December 1, 2014 Comments on  
Proposed Clean Power Plan

Re: Comments on Proposed Carbon Pollution Emission Guidelines for Existing Electric Utility Generating Units (EGU).

**COMMENTS BY THE TEXAS COMMISSION ON ENVIRONMENTAL QUALITY  
REGARDING THE CARBON POLLUTION EMISSION GUIDELINES FOR EXISTING  
STATIONARY SOURCES: ELECTRIC UTILITY GENERATING UNITS; PROPOSED  
RULE; EPA DOCKET ID NO. EPA-HQ-OAR-2013-0602**

Figure 1: World Carbon Dioxide Emissions by Region, United States Energy Information Administration, International Energy Outlook 2013.

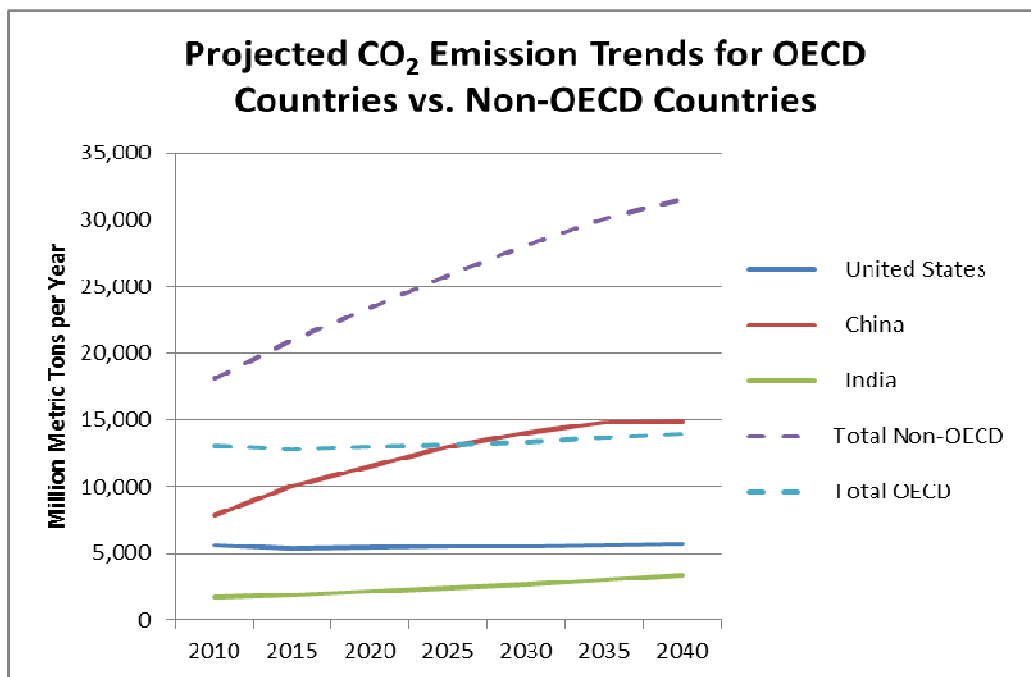
The EPA's proposed rule will not have any significant effect on global CO<sub>2</sub> emissions. As illustrated by Figure 1, World Carbon Dioxide Emissions by Region, the reduction in CO<sub>2</sub> in the United States expected from this proposal will be greatly exceeded by the increases in CO<sub>2</sub> emissions from other countries, most notably China. The table in Figure 1, prepared by the United States Energy Information Administration, compares CO<sub>2</sub> emissions from countries that are members of the Organization of Economic Co-operation and Development (OECD) to CO<sub>2</sub> emissions from non-OECD countries. According to the United States Energy Information Administration, the United States, China, and India are the top three coal-consuming countries in the world. While United States CO<sub>2</sub> emissions from 2010 through 2040 are projected to increase less than 0.1% per year, CO<sub>2</sub> emissions from China and India are increasing at more than 2% per year. The average rate of increase in annual CO<sub>2</sub> emissions in China alone from 2010 through 2030 is more than 300 million metric tons of CO<sub>2</sub> per year. As shown in Figure 2, Projected CO<sub>2</sub> Emission Trends for OECD Countries vs. Non-OECD Countries, China's CO<sub>2</sub> emissions are projected to exceed the total CO<sub>2</sub> emissions of all OECD countries by 2030. The average annual rate of increase in annual CO<sub>2</sub> emissions per year for all non-OECD countries from 2010 to 2030 is approximately 500 million metric tons. The EPA projects that the proposed rule will reduce annual CO<sub>2</sub> emissions in the United States by between 545 – 555 million metric tons per year by 2030. The total increase in annual CO<sub>2</sub> emissions from non-OECD countries from 2010 to 2030 is projected to be 9,988 million metric tons per year, 18 times the total annual CO<sub>2</sub> reductions EPA expects from the proposed rule by 2030.

Figure 3: China’s Net Electricity Generation by Fuel, United States Energy Information Administration, *International Energy Outlook*, 2013.

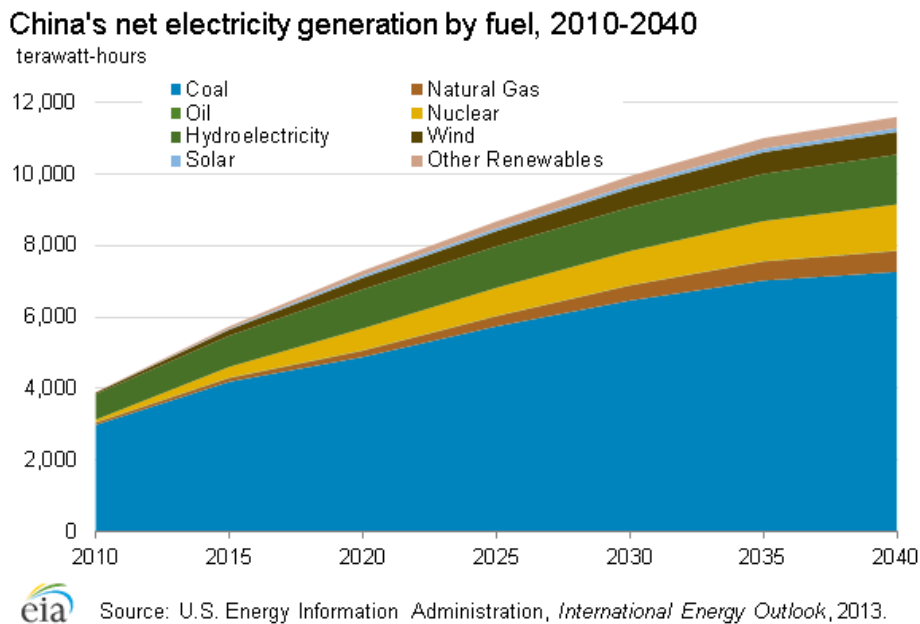
The Energy Information Administration’s data also show that CO<sub>2</sub> emissions from the United States EGU fleet are relatively stabilized compared to emissions from China and other non-OECD countries. The EPA’s own IPM modeling files in the base case demonstrate that this is expected to continue into the future. The IPM base case projections show that annual United States CO<sub>2</sub> emissions from fossil fuel-fired EGUs greater than 25 megawatts are projected to only increase approximately 181 million short tons from 2016 to 2030 without the EPA’s rule in place. President Obama’s recent announcement of an agreement with China on CO<sub>2</sub> emissions only maintains the pressure on the U.S. electric utility sector to reduce emissions while allowing China to continue to grow its emissions for 16 years. If the federal government wishes to have a real effect on reducing global CO<sub>2</sub> emissions, its efforts would clearly be better spent working with countries like China to gain binding commitments to reduce their increasing CO<sub>2</sub> emissions rather than attempt to force reductions on the United States electric power fleet, which is relatively stabilized compared to countries such as China and India.

**Figure 1. Present Value of Spending (blue) and Climate Benefits (red) by Year (\$ billions per year, 2011\$)**

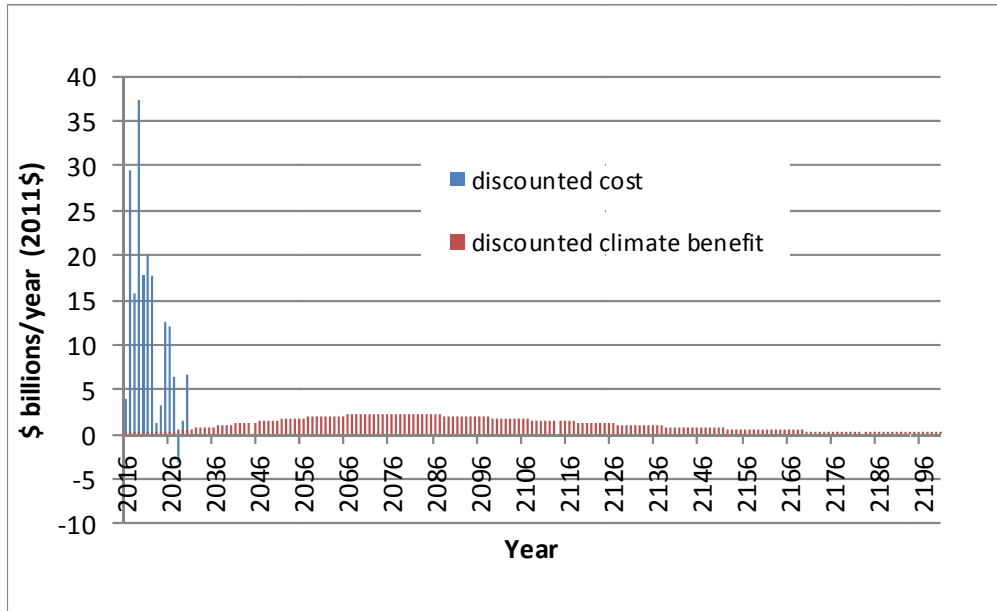
Any RIA that involves large up-front spending with delayed benefits should report the temporal patterns in the estimated benefits and costs. Figure 1 presents that temporal pattern showing the timing of the spending and the timing of the benefits (both discounted to 2014). Figure 2 combines these into cumulative net benefits over time; as visible in the figure, the net benefits only become positive after 2100. Section II explains how I derived these results using an SCC model, and their robustness to alternative modeling assumptions.

**Figure 4: ERCOT Generation By Fuel, April 11-17, 2014**

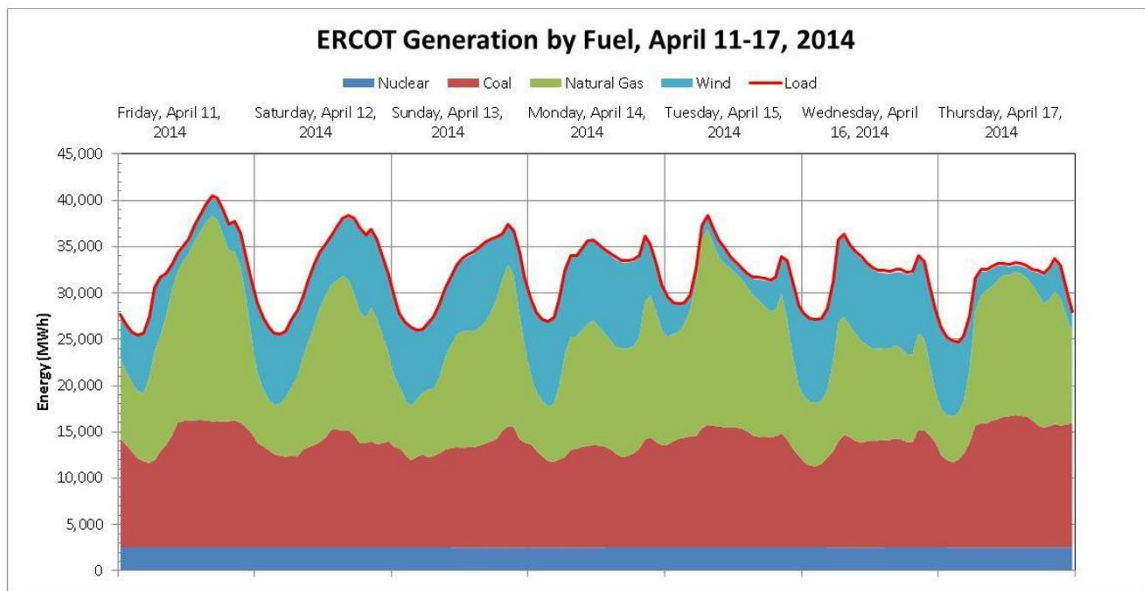
EPA also fails to recognize that the growth of renewable energy generation in Texas has also impacted the heat rate of power plants in Texas, and will increasingly make it difficult to maintain even the current heat rates. Figure 4 shows the ERCOT generation fleet stack for a week in April 2014.

Figure 4 illustrates that Texas’s 11,000 MW of wind power has substantial impacts on the operations of coal plants, particularly in the spring. This result occurs during days with relatively low load, gas-fired generation is often curtailed as much as can feasibly be done (while still ensuring adequate ancillary services and reserves on the grid), necessitating ramping of the coal fleet in order to maintain system reliability. This ramping naturally results in coal plants running in a less than optimally efficient manner, and consequently a higher heat rate. EPA’s method of calculating state emissions rates does not take into account this unavoidable consequence of the introduction of large amounts of renewable energy into power systems, and further illustrates the flaws in Rule 111(d).

**Figure 5: Typical Summer Load Profile**

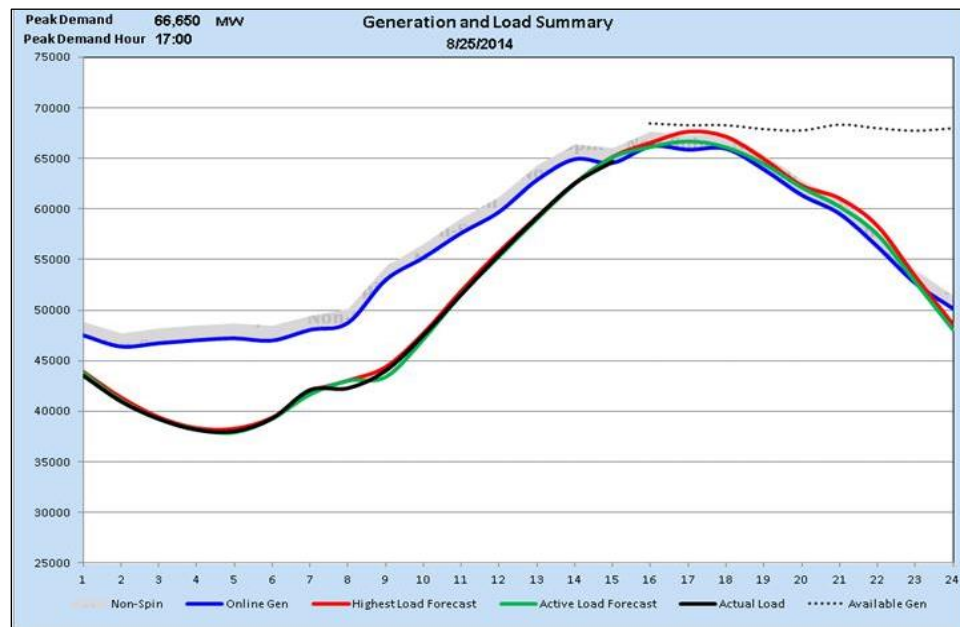
Figures 5 and 6 below illustrate seasonal load profiles experienced in Texas. Figure 5 is a typical August day in Texas. The ERCOT load almost doubles on a summer day, increasing from about 36,000 MW to over 68,000 MW. Simply put, during Texas' (and other states') peak demand days, all available generation must be running in a reliable fashion. That means coal plants must run consistently around the clock due to their inability to effectively ramp to meet customer demand.

**Figure 6: Spring/Fall Load Profile**

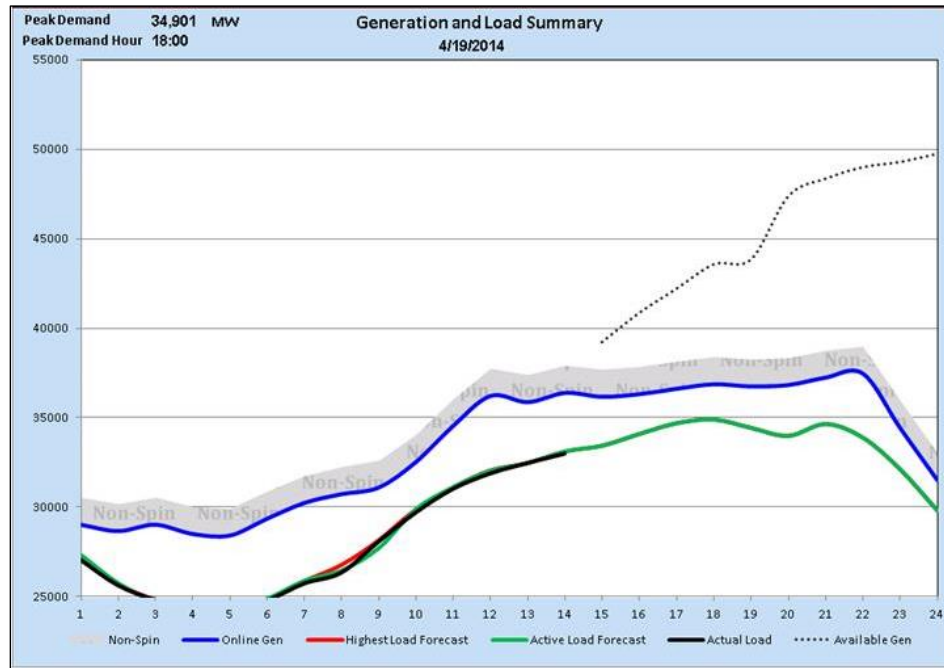
Similarly, Figure 6 is a typical spring or fall day and shows how low the load in ERCOT typically can dip in the spring or fall. Texas must have a balanced, diversified generation mix in order to be able to start up generation facilities as load climbs, and then be able to ramp them down as load declines.

Figure 6 demonstrates a different problem that can occur with too much renewable generation as Rule 111(d) seeks to mandate through application of Block 3. Between 3:00 a.m. and 6:00 a.m. electricity consumption can drop below 25,000 MW. ERCOT previously has experienced days in which wind has provided as much as 38.4%<sup>98</sup> of the generation on the system. Rule 111(d) fails to acknowledge this reality through its use of Block 2’s methodology, which creates both practical difficulties and perverse results. Wind turbines in Texas typically have a much higher capacity factor during spring and fall months. During the spring and fall a 20% renewable energy goal as proposed by EPA under Block 3 could put more renewable generation on the grid than there is existing load. Consequently, during the early morning hours ERCOT would have to both curtail a substantial amount of the wind and back down or even shutdown much of the nuclear fleet and all other thermal generation, which would simultaneously reduce the

**Figure 7: 93% Drop in Wind Production in 12 Hours**

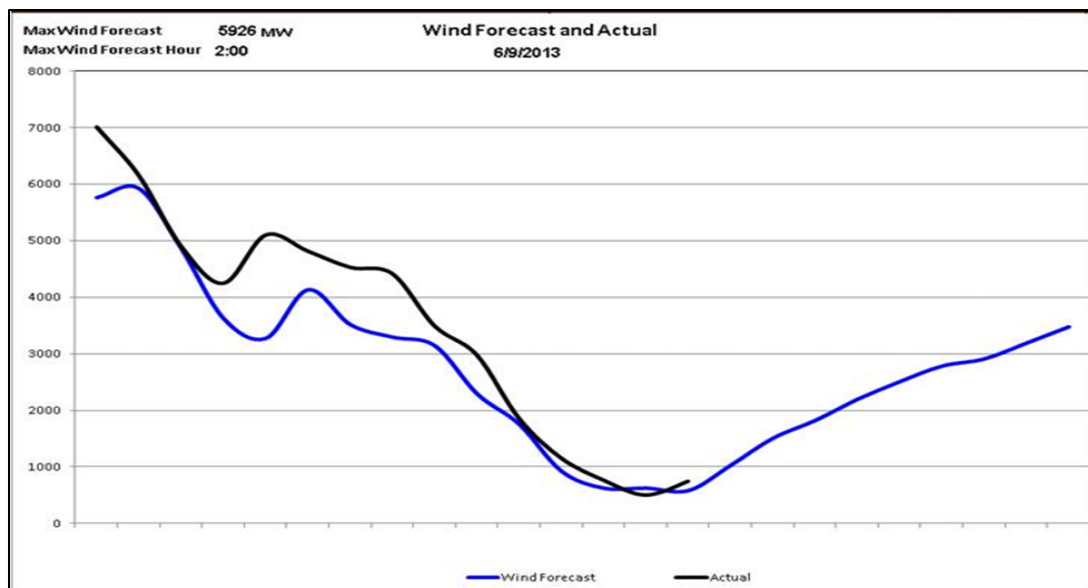
On the day referenced in Figure 7, wind generation dropped 93% (a total loss of 6,500 MW) over 13.5 hours. An over reliance on wind coupled with a possible 93% reduction of wind generation on any given day mandates an increased reliance on flexible gas generating units and less on base load units to ensure system reliability and sufficient availability of power.<sup>99</sup> This introduces enormous costly redundancies into ERCOT’s system and likely means that nuclear generating units will be backed down when it is windy, only to be replaced with combined cycle or simple

**Figure 8: Variability of Wind Can Be Frequent and Extreme**

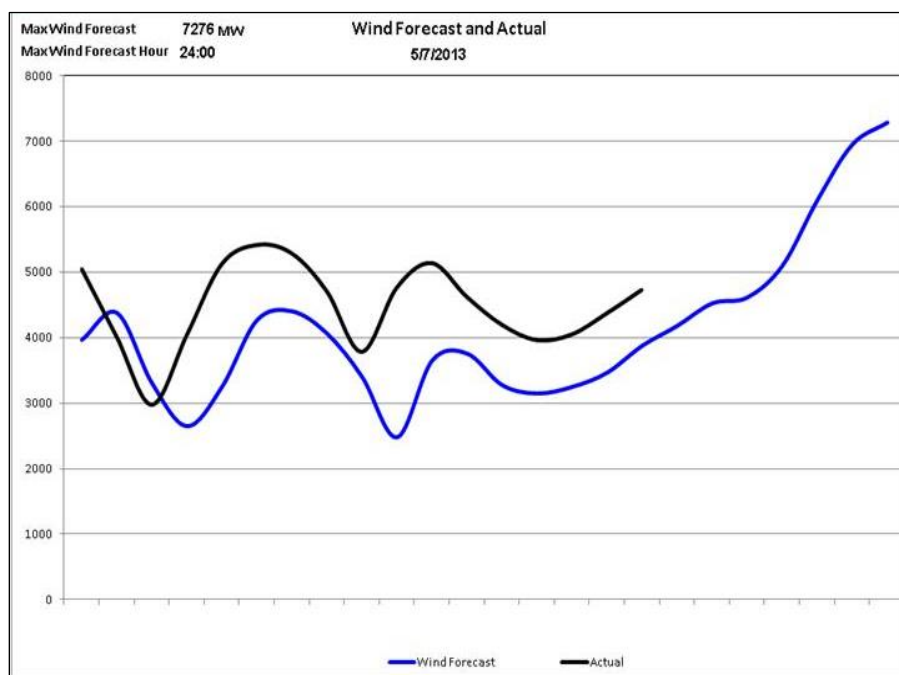
An example of what the ERCOT generation mix must be able to handle over very short periods of time is shown in Figure 8 below.

On May 7, 2013, ERCOT experienced three cycles of fluctuations in wind generation between 2,000 and 8,000 MW over a 14 hour period. This is equivalent to having 1,500 MW of thermal generation trip off line three times in 14 hours. Flexible natural gas-fired generation is capable of matching the variability of wind and other renewable generation best due to its ramping ability; however, even gas combined cycle generation is most efficient when operated at or near 100% capacity.

**Figure 14: Growth in Renewable Energy Required by Rule 111(d)<sup>163</sup>**

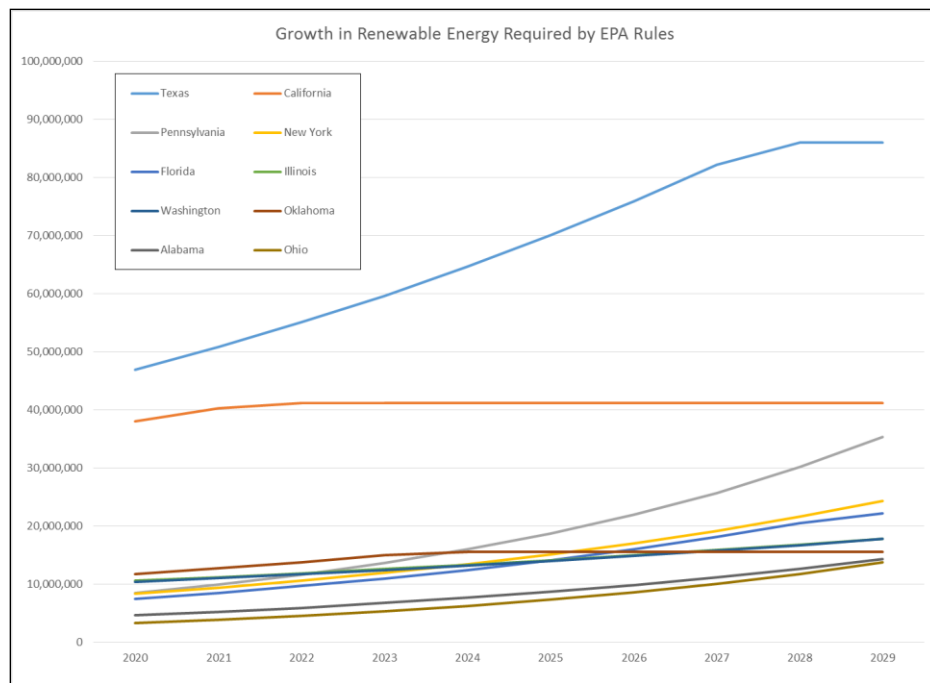
would be required to increase its renewable portfolio by 153% over the next 8-14 years, while the next largest renewable energy producer, California, would only be required to increase its renewable energy portfolio by 37%.<sup>160</sup> The required increase in Texas’s renewable energy fleet required under the rule would be greater than the increases of 29 states combined.<sup>161</sup> Finally, Texas’s renewable energy portfolio resulting from Rule 111(d) would be larger than the present day wind and solar fleets of every country in the world, except for the U.S.<sup>162</sup> The magnitude of Texas’s renewable energy mandate compared to certain other states is illustrated below in Figure 14. EPA offers no credible or reasonable explanation for this disparate treatment of Texas in the proposed rule.
